Administrative Staff Report

Project Name: Silverdale Recycling and Garbage Facility (RAGF)

Type of Application: Administrative Conditional Use Permit (Type-II)

Permit Number:23-00526

Figure 4
 Hydrogeologic Cross Section
 Silverdale RAGF

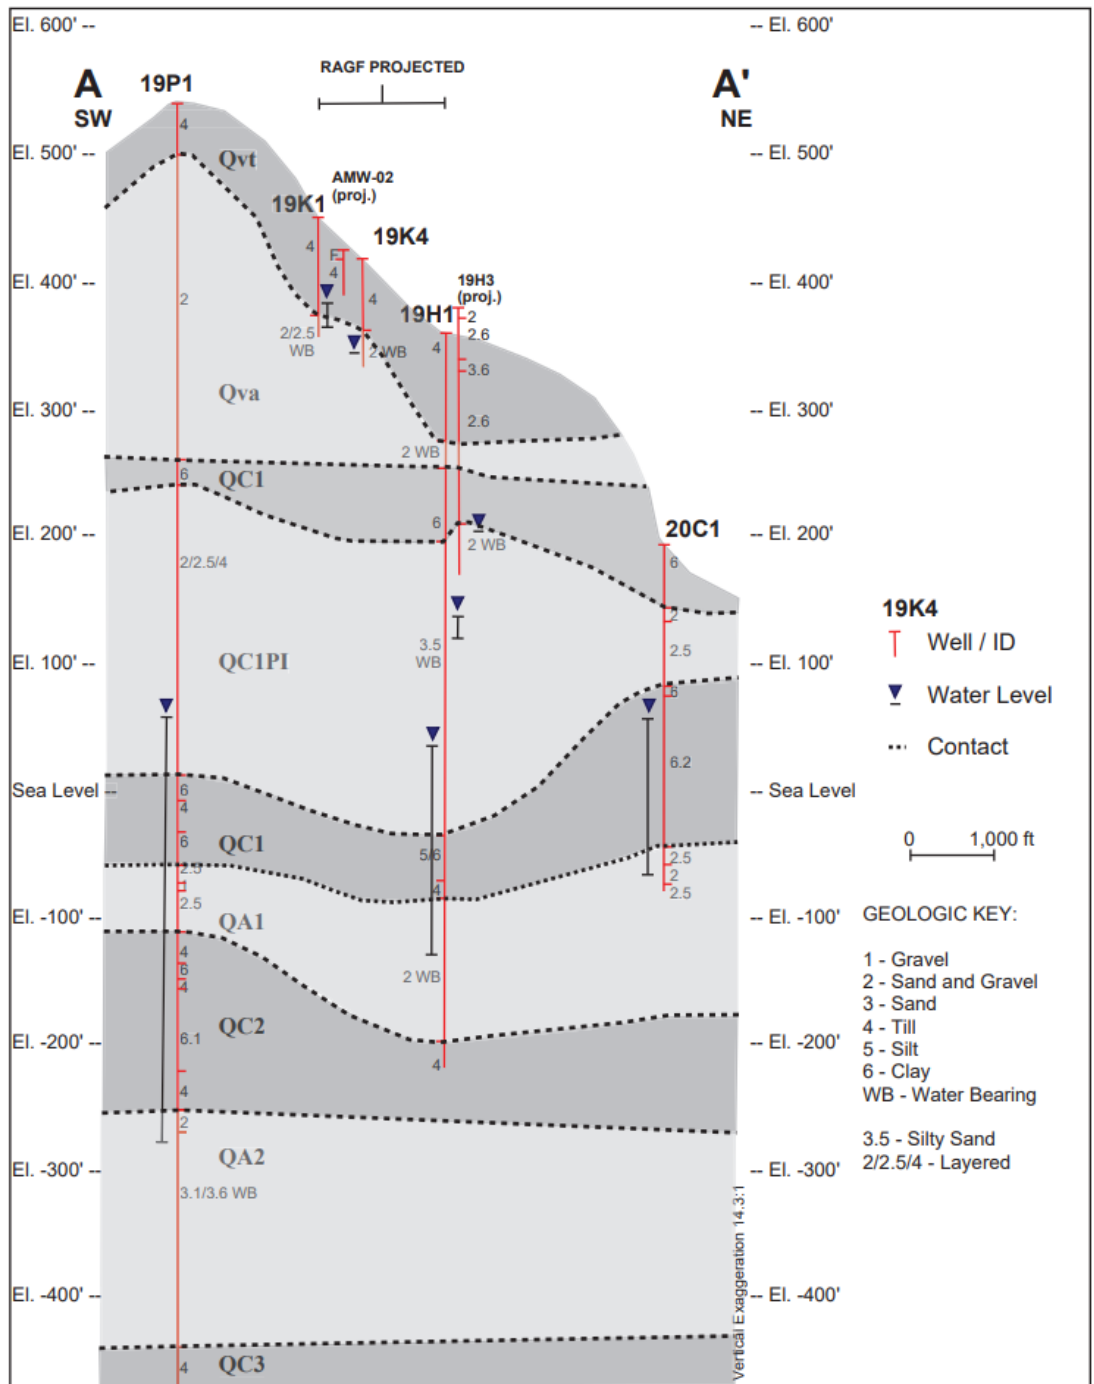
Staff Comment: The Silverdale Water District and Kitsap Public Health District have reviewed the hydrogeological report. The agencies are in concurrence with the findings in the report there is more than adequate separation within the aquitard (See Attachment B Hydrogeological Cross Section). It is recommended that the County follow best management practices to reduce potential threats to groundwater contamination, consistent with RCW 36.70A.170 A spill response plan was prepared for the probability of an accidental spill (See Conditions 31).
